Ohio Field Office Fernald Area Office

TRANSMITTAL OF REVISED AREA 2, PHASE I EXCAVATION STRATEGY FOR 1999

SOUTHERN WASTE UNIT EXCAVATION (Survey 2/99)

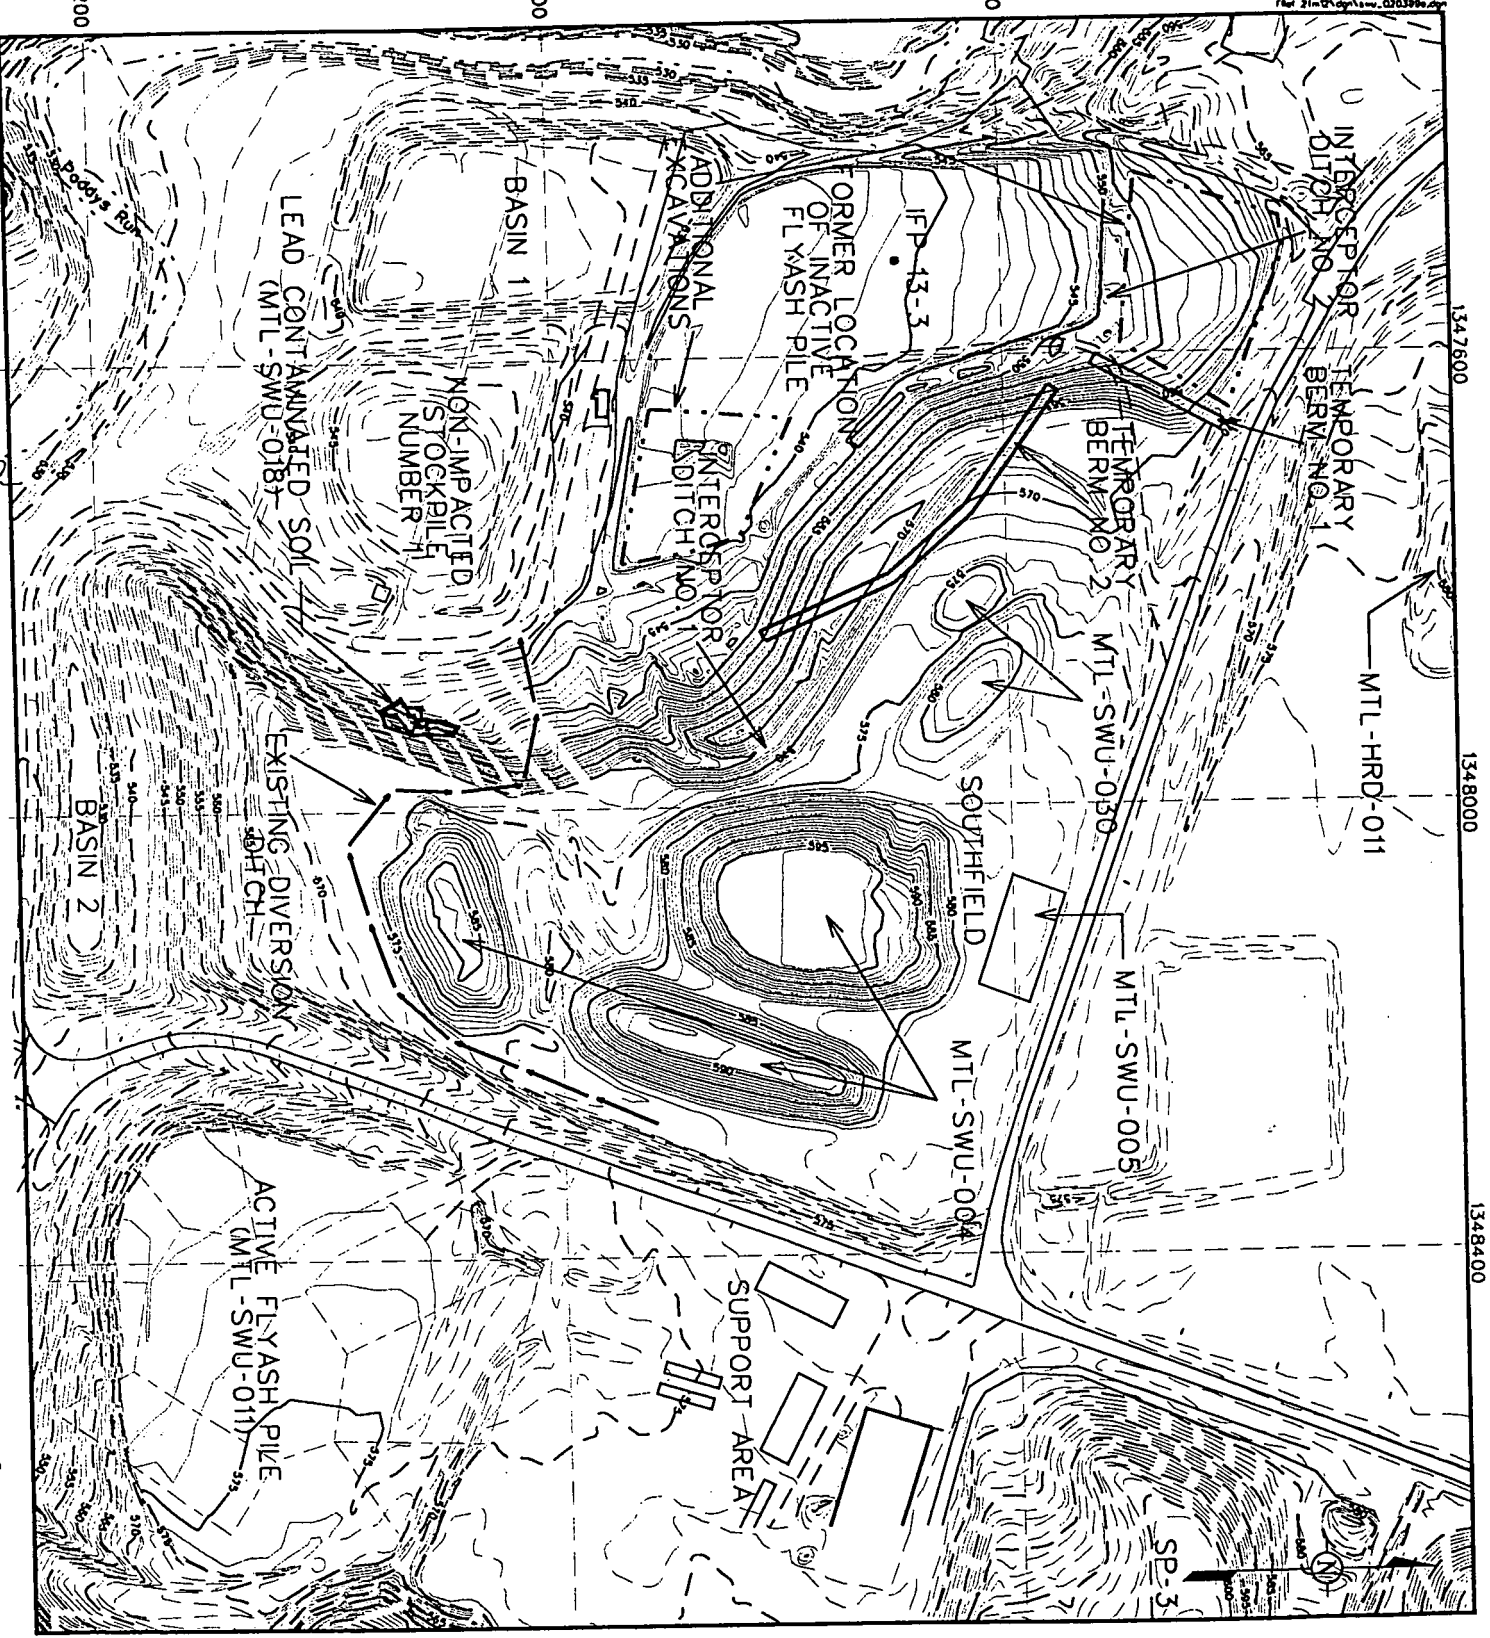
Initially, Temporary Berm No. 1 will be constructed to divert uncertified South Field surface water runoff from entering the former Inactive Flyash Pile (IFP) area north of Interceptor Ditch No. 2 (see enclosed figure). Once the berm is installed, at least four additional feet of material north of Interceptor Ditch No. 2 will be excavated, along with a spot excavation south of Interceptor Ditch No. 2. This material was found to exceed the uranium Final Remediation Level (FRL) at the conclusion of the Calendar Year (CY) 1998 excavation season. When all of the above-FRL areas in the IFP have been excavated and Real-Time Instrumentation (RMS or HPGe) demonstrates that the uranium FRL has been attained, the upper portion of Interceptor Ditch No. 2 (west to east section) will be excavated and disposed of in the On-Site Disposal Facility (OSDF). This will allow the surface water runoff from the northern portion of the former IFP to drain into the southern portion.

Interceptor Ditch No. 1 will be removed from upstream to downstream as the surrounding lifts of impacted material are excavated. Temporary Berm No. 2 (which replaces the originally designed Interceptor Ditch No. 3) will be constructed as the topography is lowered to design grade in order to protect the exposed Great Miami Aquifer from uncertified surface water runoff from the South Field. The existing drainage pattern of the South Field, which diverts flow from the northern portion to Retention Basin 1 and from the southern portion to Retention Basin 2, will be maintained throughout the excavation.

Temporary Berms No. 1 and No. 2 will be removed when design grades are met and a real-time scan demonstrates that the FRL has been reached upgradient of the berms. This will occur in CY 2000. Likewise, the remainder of Interceptor Ditch No. 2 will be removed when design grades are met and real-time scanning demonstrates that the FRL has been reached upgradient from the ditch. The material removed from the Temporary Berms and Interceptor Ditch No. 2 will be excavated and disposed of in the OSDF. These locations will be scanned with real-time instrumentation to verify that the surface meets the FRL, and then graded for positive drainage.

Notes:
1. Temporary Berm No. 1 and No. 2 are to be constructed as excavation progresses.
